AMENDMENTS TO THE DRAWINGS

REMARKS

Drawing Objections

FIG. 2a

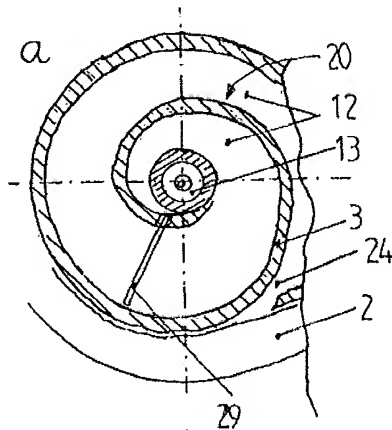
In order to understand the Helmut reference (as this is a German language patent reference) in the context of the obviousness rejection, Applicant hereby provides a summary of the relevant portions from the Helmut reference. With reference to FIG. 2a of Helmut, there is a heat conducting element 3 made of metal connecting the inner wall of the vacuum tube 2 to the inner tube 13. The means for collecting and concentrating solar energy is indicated to be an “absorber” 3. Column 3, line 63 of the original German Helmut reference specifies this absorber to be made of blackened copper-containing material. The absorber 3 is positioned within the so-called “Sorbensraum 12” (adsorption area), a place comprising water saturated air (*See* column 4, lines 36 to 40). The heat-conducting elements

are described as assuming various shapes (*See* column 3, lines 46 to 51). With respect to FIG. 2f, the webs (in German, “Stege”) 23 are resiliently (in German, “federnd”) positioned in an adapted manner at the inner wall of the vacuum tube (*See* column 3, lines 51 to 53). FIG. 2a shows a spiral heat-conducting element 3 almost covering 720 degrees.

FIG. 2f

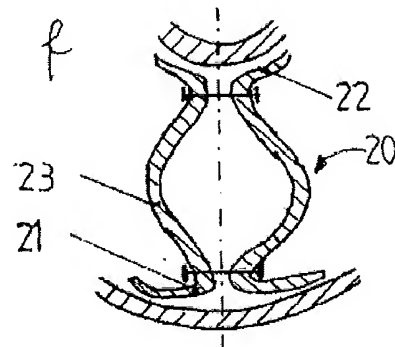
The Examiner asserts that Helmut discloses a heat-conducting element that is contacting the outer wall of the fluid-conducting pipe system and is pre-stressed against the inner wall of the vacuum tube and the fluid-conducting pipe system (based on the word “resilient” on page 2, paragraph 5 of the machine language translation of Helmut). Applicants respectfully disagree. Helmut discloses in column 4, lines 3 to 7, that especially for spiral arrangements (“besonders innerhalb spiralförmiger Anordnungen”) it is preferable (“zweckmässig”) to provide elements 29 as spacers (“Abstandhalter”) to provide a diametral connection towards the pipe system 13 (“dass eine diametrale Verbindung zur Wärmeträgerführung zustande kommt”). It is impossible to have rigid spacer elements 29 and resilient heat-conducting elements 23 exerting such a spring-like function in the spiral shape embodiment shown in FIG. 2a. Although it is mentioned in column 3, lines 40 to 43 that such functionality would be realized (assumingly, in the context of the non-spiral embodiment of FIG. 2f), the presence of the spacer elements 29 in the spiral embodiment of FIG. 2a clearly shows that the distance is maintained through the spacer elements 29 and not by any prestress force. Therefore, Helmut fails to disclose the “prestressed” limitation.

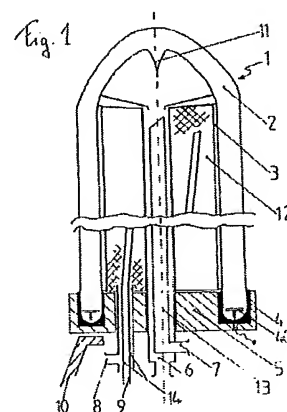
Ghela shows the heat-conducting element attached at the outer wall of the fluid pipe system (See column 11; FIGS. 15 and 16). Supports 72 in Ghela are called absorbing supports. However, the disclosure of FIG. 16, as read by someone skilled in the art is different than interpreted by the Examiner. Specifically, FIG. 16 depicts an integrated embodiment, wherein a wall 71 is a metal or PVC conduit; surface 73 is transparent, whereas walls 75, 76 with surface 77 are not; surface 77 is a reflecting surface (See column 11, line 20); webs 72 are the absorbing portions (as in other embodiments of the Ghela webs 10); volumes 79 are evacuated; and the webs 72 are attached at the integrated inner tube 71 for transfer of energy to the fluid 78.

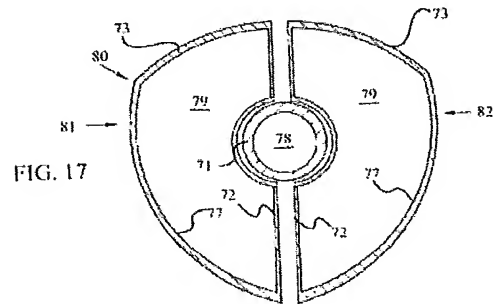
Furthermore, if the teachings of Ghela are used in combination with those of Helmut (and/or Takeuchi), the teaching of FIG. 17 must be used, because only FIG. 17 of Ghela uses a specific conduit similar to that of Helmut and Takeuchi, instead of an integrated solution that is depicted in FIGS. 15 and 16 of Ghela -- such a specific pipe

facilitates connecting with plumbing fixtures (*See* column 11, lines 51 to 59). Column 12, lines 20 to 38, describing FIG. 17, indicates a metal pipe, however, the heat-conducting elements only “fit snugly” (*See* column 12, line 32) into the volume. Ghela does not mention an attachment to a separate inner fluid tube and no prestress aspect. This is understandable, as the attachment is only used if the inner pipe element, at which the web 72 (being the absorber element) is attached, is part of vacuum volume 79 and not a different fluid pipe system.
